PROPOSAL 2-1 (2009)

SCOPE: Sec. 12.2.5 of the 2009 Provisions

Figure A

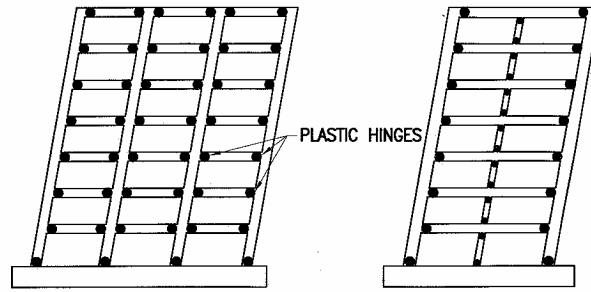
8 The proposal represents a fundamental modification of requirements for strong-column/weak-
9 beam because column and beam moment strengths are to be summed for all columns at each
10 level for each plane of resistance. The sum of column strengths framing *into the underside of a*
11 *level only* are compared to the sum of beam strengths at that level. For example, in the three-bay
12 planar frame of Figure A, the formula compares the sum of four column moment strengths to the
13 sum of six girder moment strengths.

Figure B

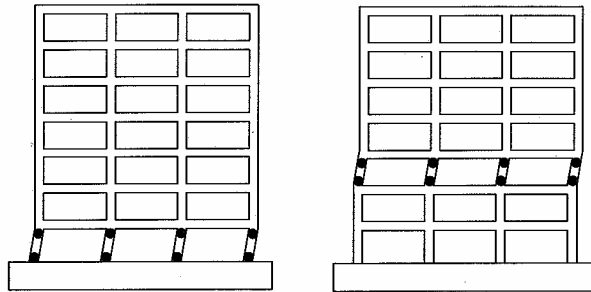
14 The story approach is shown by plastic analysis studies to be an appropriate provision against the
15 formation of undesirable story mechanisms. Desirable and undesirable plastic mechanisms are
16 shown in Figure B.

22 Compared to current requirements, this proposal requires, on average, stronger columns and/or
23 weaker beams. The proposal can provide design flexibility and economy by allowing individual
24 columns to be weaker than adjacent beams, provided that there is enough strength in other
25 columns to prevent a story mechanism. (See upper right of Figure B)
